CITY OF CORCORAN
Corcoran Planning Commission Agenda
August 6, 2020 - 7:00 pm

RE: **PUBLIC HEARING.** Nelson International Conditional Use Permit, Site Plan and Variance for the property at 10409 County Road 101 (PID 01-119-23-41-0001) (city file no. 20-022)

Subject: Nelson International – Plan Review Comments

SITE PLAN
C2-1

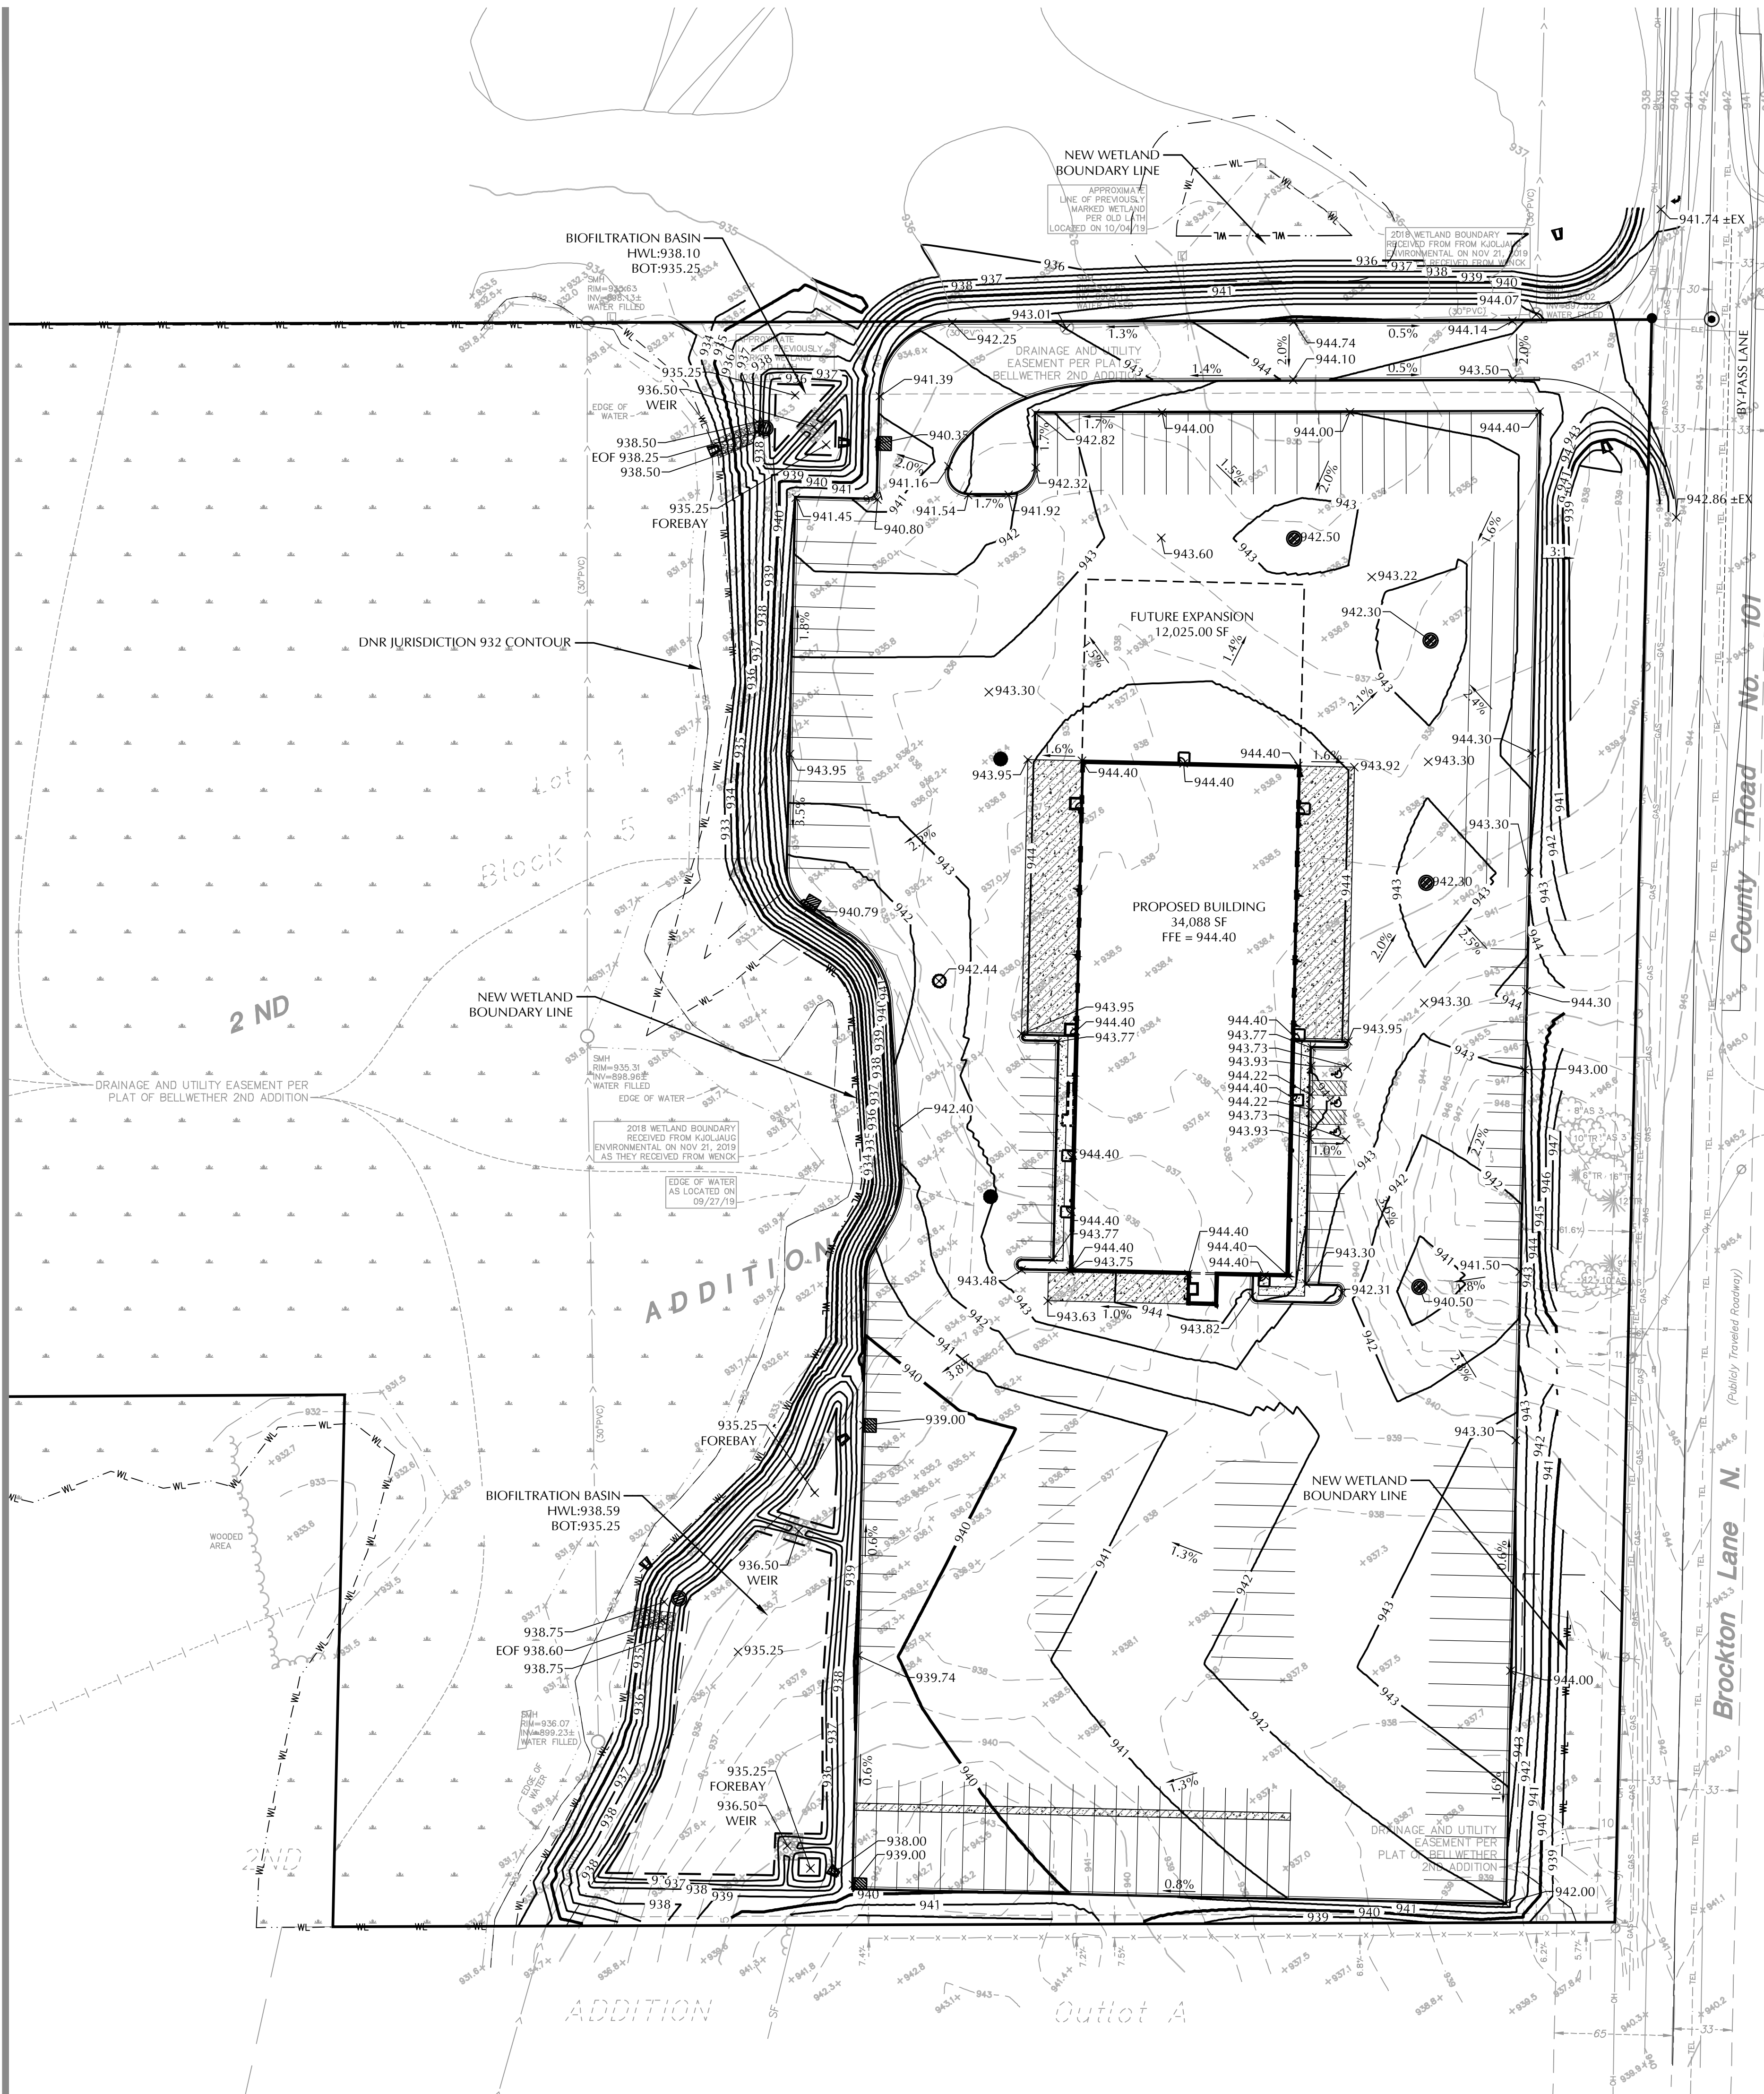
as “Overflow Parking” on the plans. These parking stalls should be removed from plans as they cannot be preserved as parking spaces if they are in the turning radius area.

The plan shows a total of 119 parking stalls for customer, company, service and overflow parking where a total of 67 parking stalls are required: 36 for retail, 13 for warehousing and 18 for auto service. Removal of the three stalls that conflict with the turning radius will leave 116 available, which exceeds the minimum requirements.

The second variance is for the 40 ft. curb cut where 32 ft. is allowed. The City Code requires compliance with the City Engineering Design Standards, which limits commercial driveway width to 32 feet at the right-of-way (Engineering Detail STR-13). The City has consistently applied this standard to other commercial and industrial areas, including the downtown industrial sites.

- d. Wall signs 2-4 are not permitted signs
 - e. Wall sign 5 should be reduced to four square feet to be in compliance.
11. Plans must be revised to allow for trucks to navigate the site without overlapping with parking stalls.

- a. Where the turn radius conflicts with parking stalls, parking stalls must be removed.
 - b. As plans are revised the site must have a minimum of 67 stalls.

UTILITY PLAN

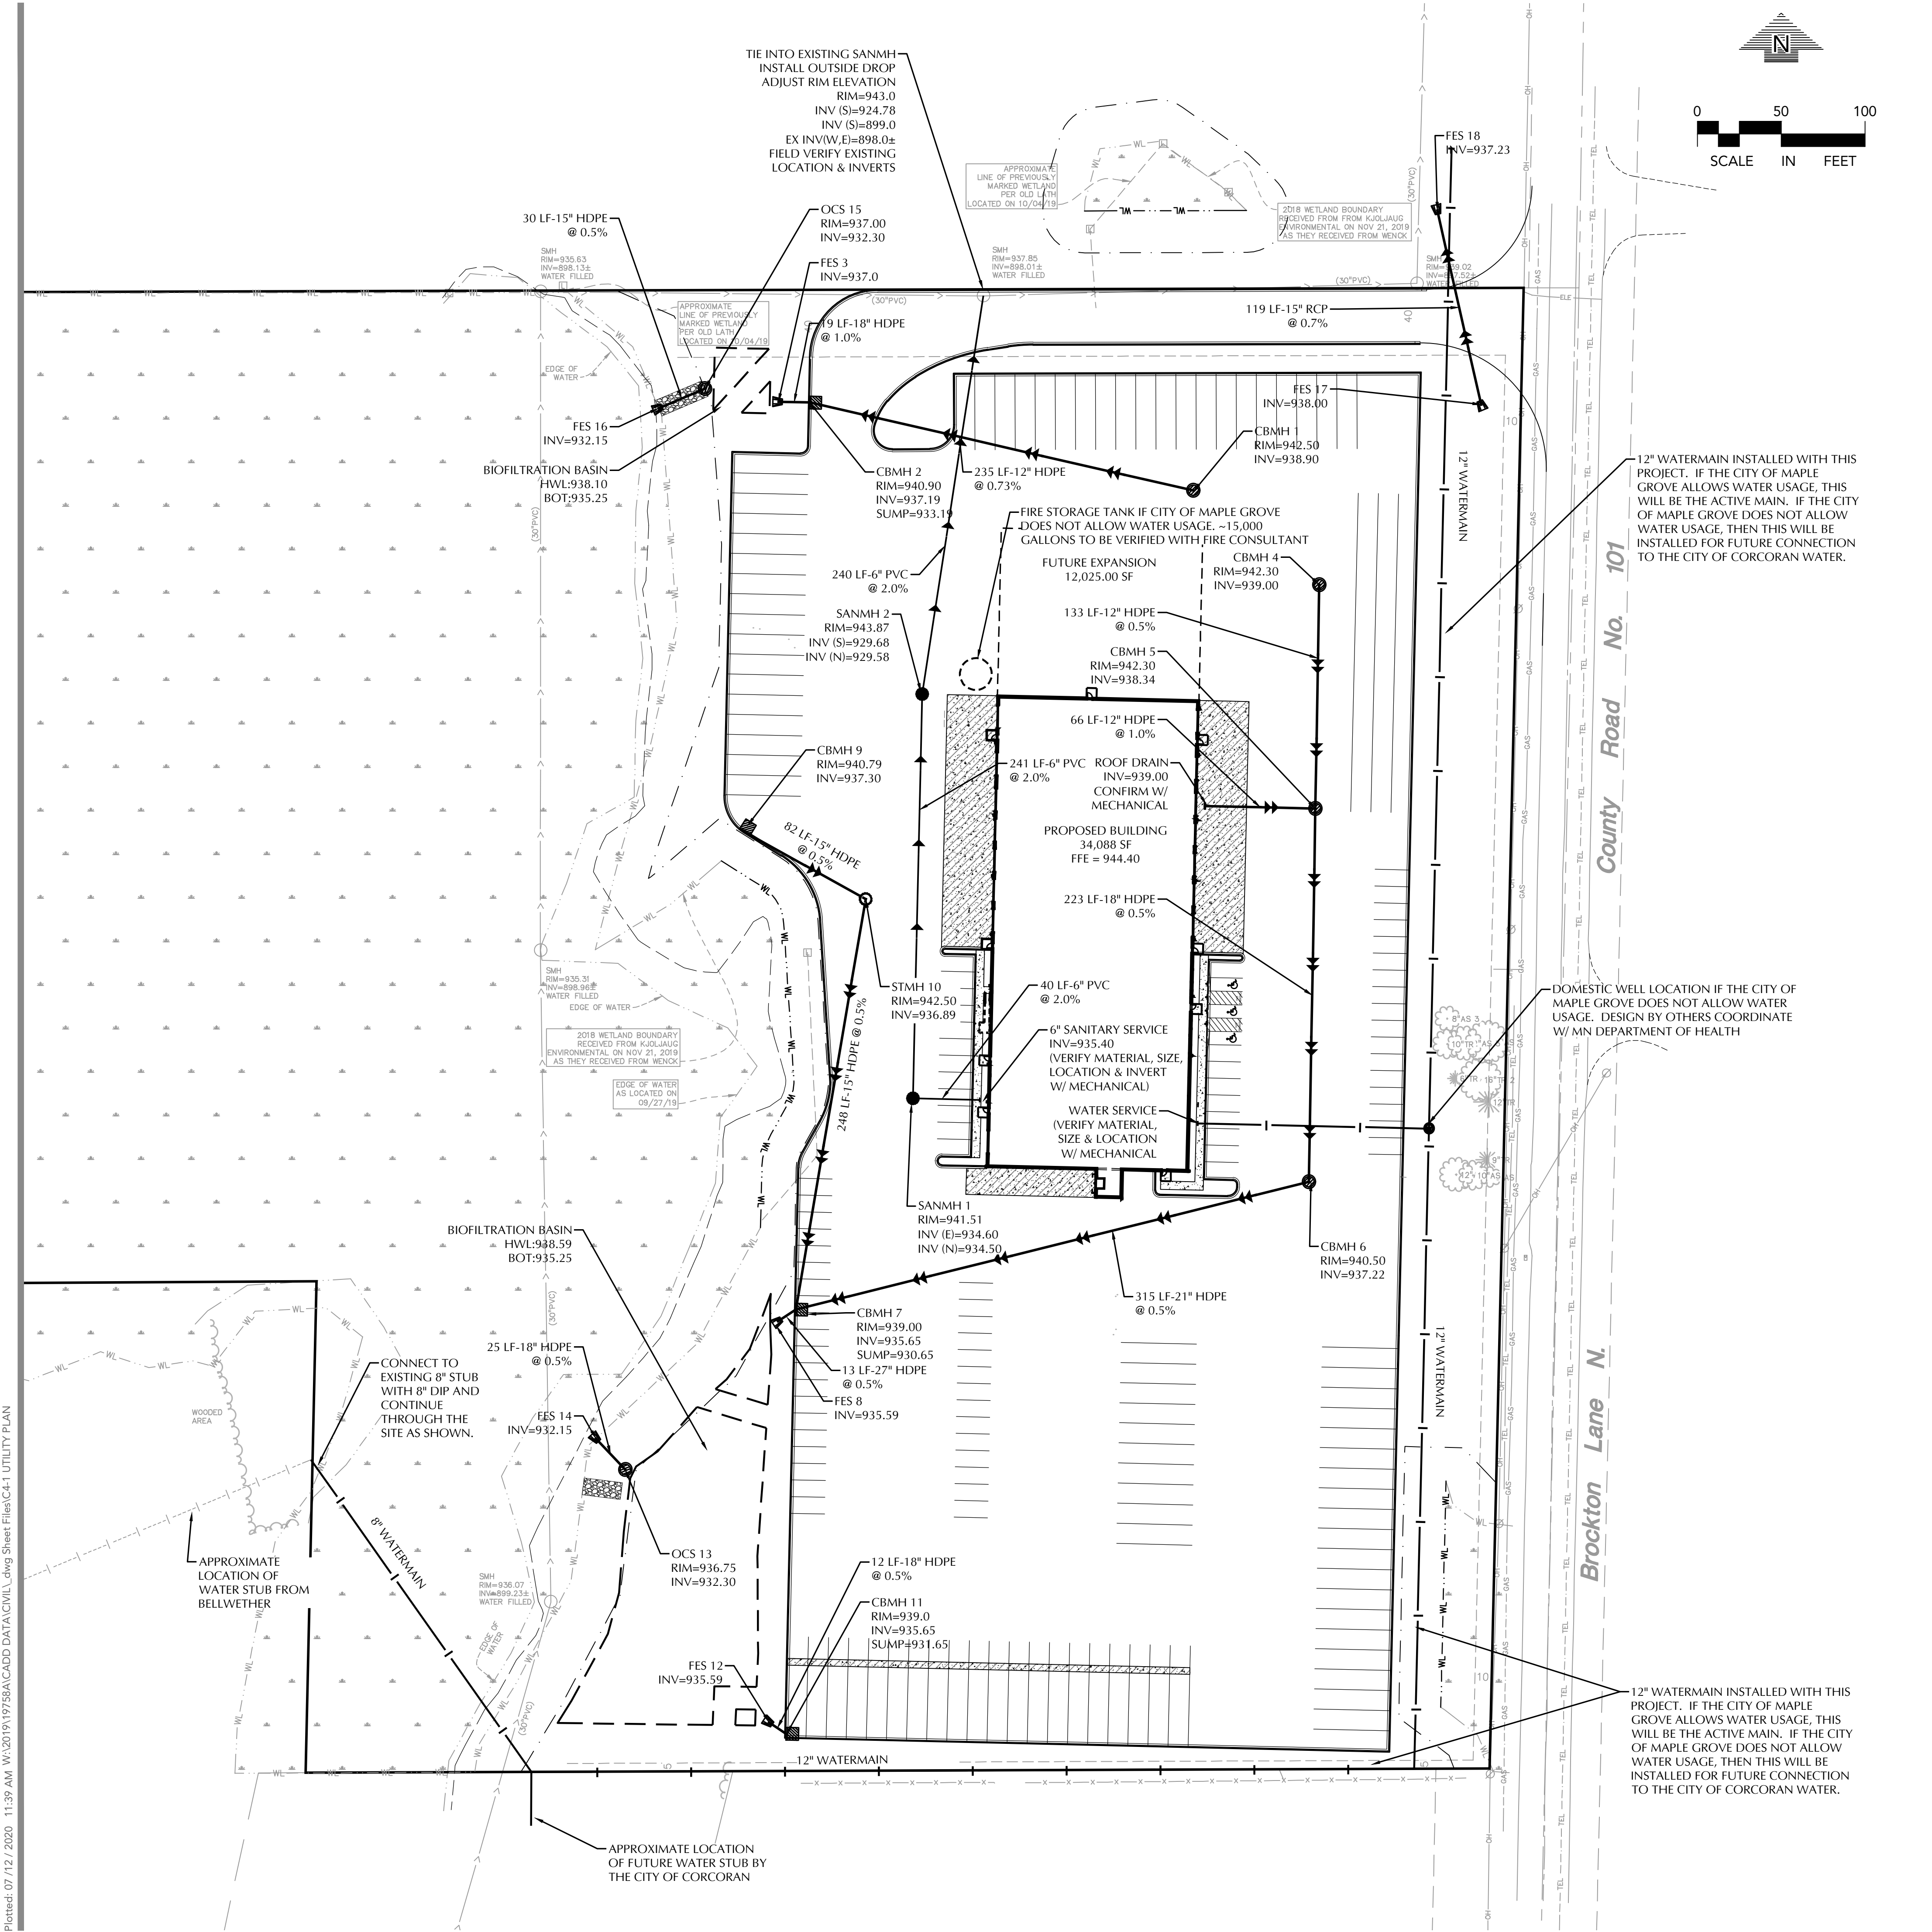
The applicant's proposed layout shows both options. If water is secured from Maple Grove, the landscaping plan or utility plan will need to be revised to avoid conflicts between the proposed trees and the proposed watermain. This issue must be resolved prior to execution of the development agreement.

- d. The landscaping plan must be revised to ensure no conflicts with the watermain along CR 101.
 - e. The planting schedule must contain the following information as required by Section 1070.050:
